# Department of Planning, Housing, & Community Development

**Meeting Date:** 30 June 2015  
**Sent To:** Commission on Architecture & Urban Design Members  
**Subject:** **10 Henry Street – Design Review, Roofing**  
**Tax ID:** 160.41-1-1  
**Case:** CAUD 2015-30  
**Copies:** Ex-officio Members; J. Berling; J. Pelletier

Figure 1: Existing Gutter and Snow Pad System (2015)

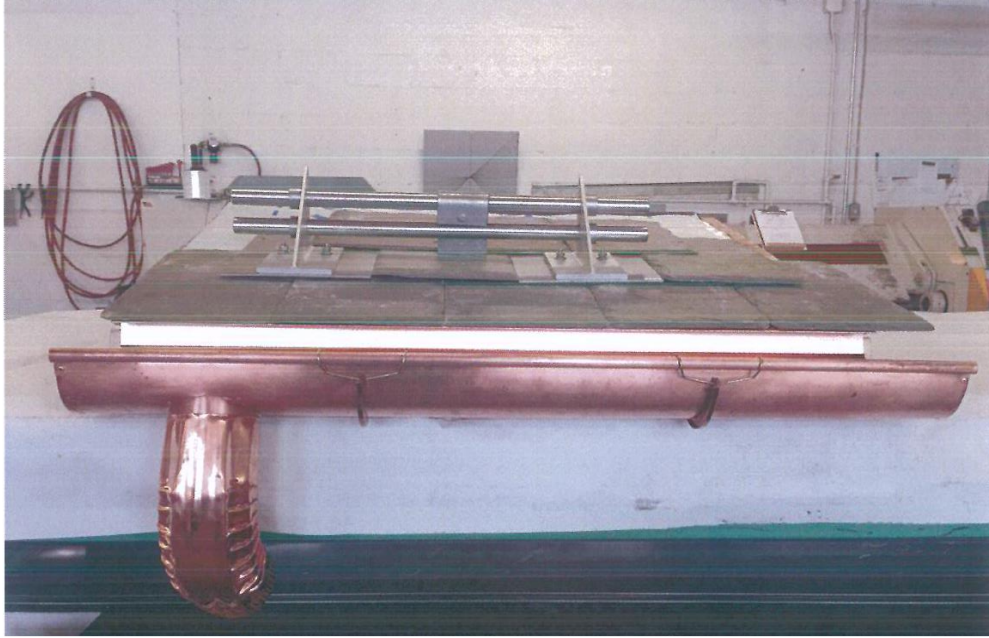
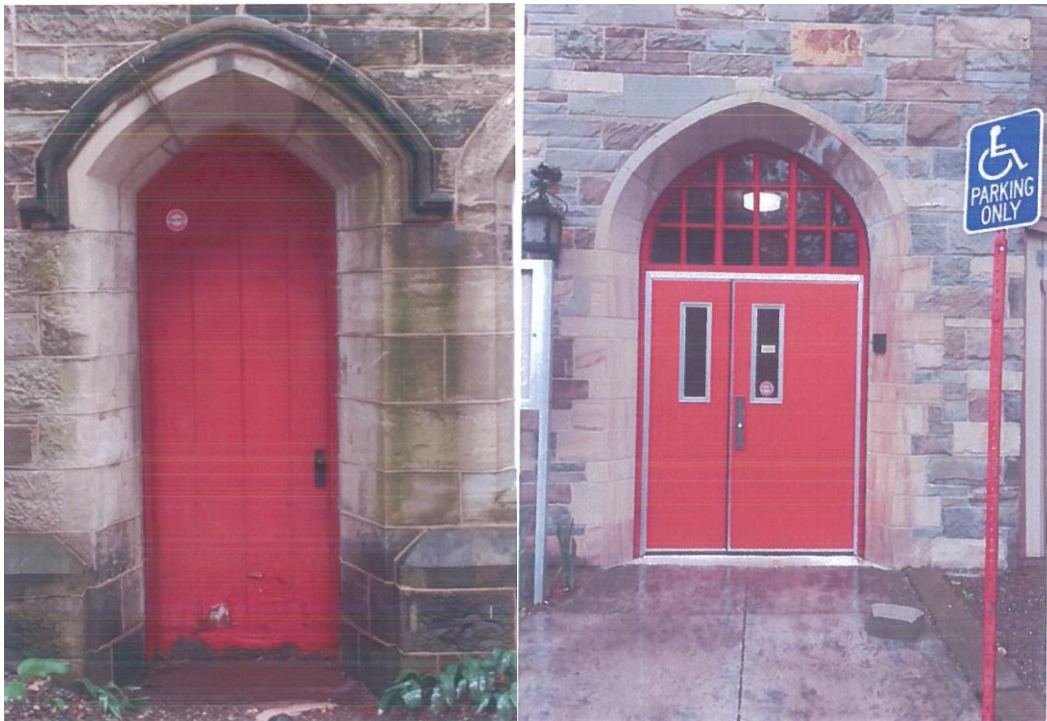
The project designer has proposed to replace the gutters, and failing snow pads on the roof of the building. The current 6" half-round gutters and downspouts in Figure 1 will be replaced with 6" copper coated stainless steel gutters and downspouts shown in Figure 2. The current failing snow pads, in Figure 1, will be replaced with a contemporary twin-pipe system, which will handle a larger snow-load than the current system shown in Figure 2. The existing wood door, located on the churches north elevation is for basement access to the church. The project developer has proposed replacing this existing wood door with a Fiberglass Reinforced Polyester (FRP) door painted in a color to match the existing door shown in Figure 3.

The existing gutters will be replaced with similarly styled gutters made from copper coated stainless steel and should add to the historic character of the building. The contemporary replacement snow pads proposed should not significantly impact the character defining features of the church, as indicated by snow pads replaced on the project developers past historic structure project shown in Figure 4. The proposed door is a minor change, as it's not the main point of ingress and egress from the building.

The proposed half-round gutters are consistent with treatments to the drainage systems as detailed in the Historic Design Guidelines for buildings. Guidelines encourage the selective repair to failing systems associated with buildings. In reference to the proposed snow pads, new snow pads should only be implemented on parts of the building where they are of necessity for the proper function and use of the building. The guidelines also indicate that wooden door frames are preferred over heavily manufactured, or otherwise synthetic materials
